Title:	Adjustment of Slide Station Motion on Flask Incubator			ID:
				0004
Date in:		Response:	Model:	Author:
2005-04-23		2005-04-23	STF130	CMA

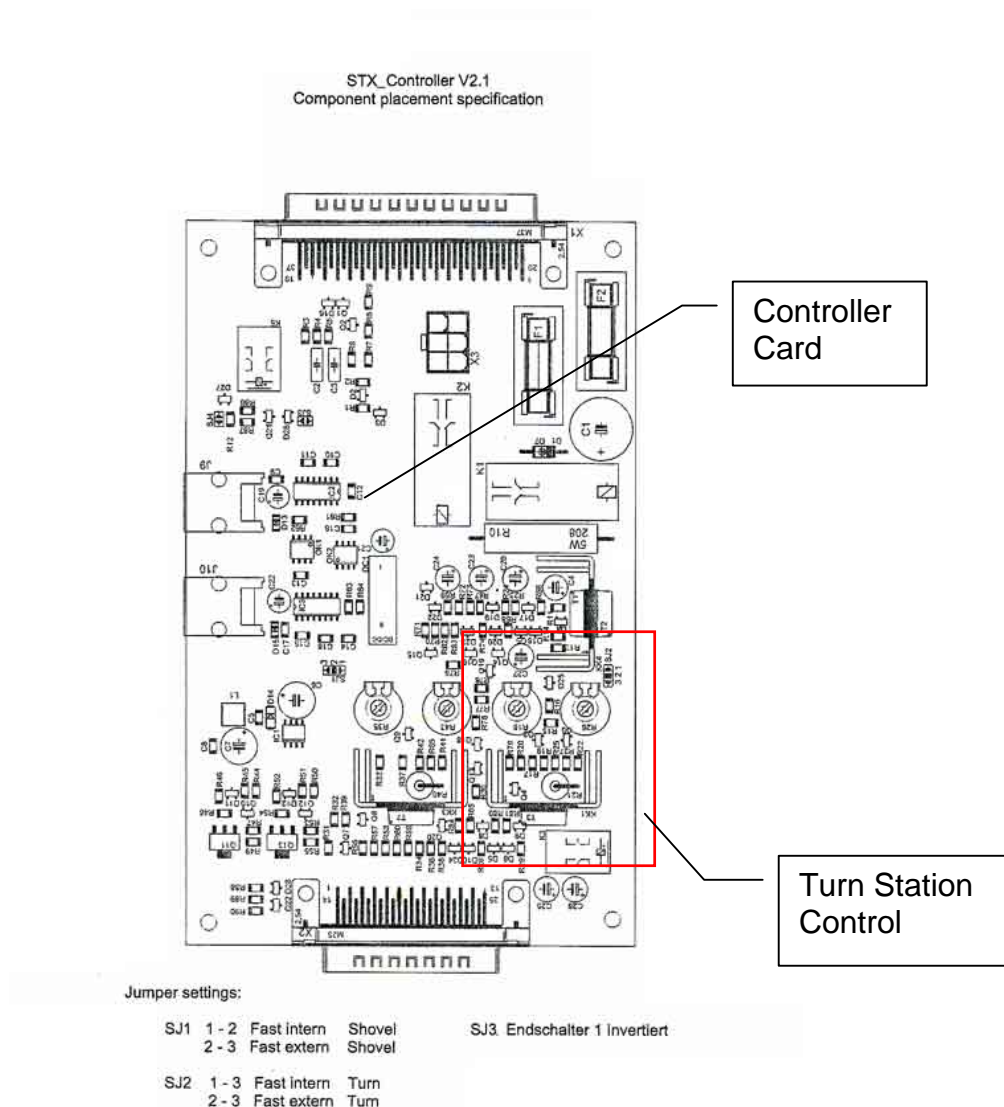
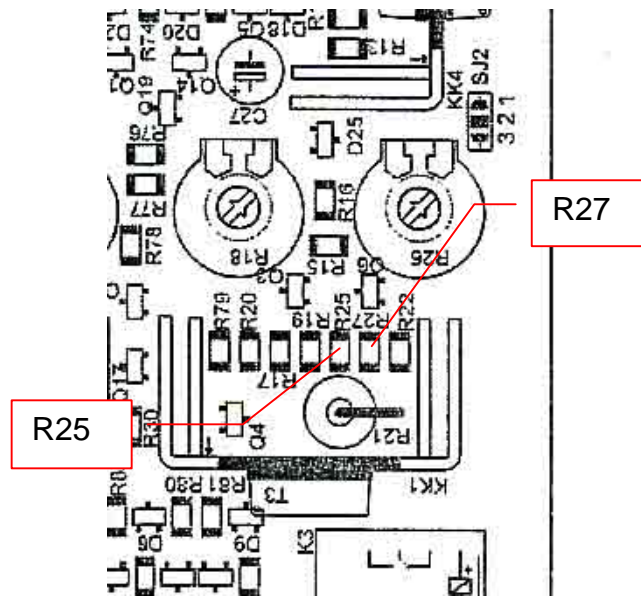
R25 and R27 are parallel.

The total resist value should be 330R. There should one resistor 330R only.
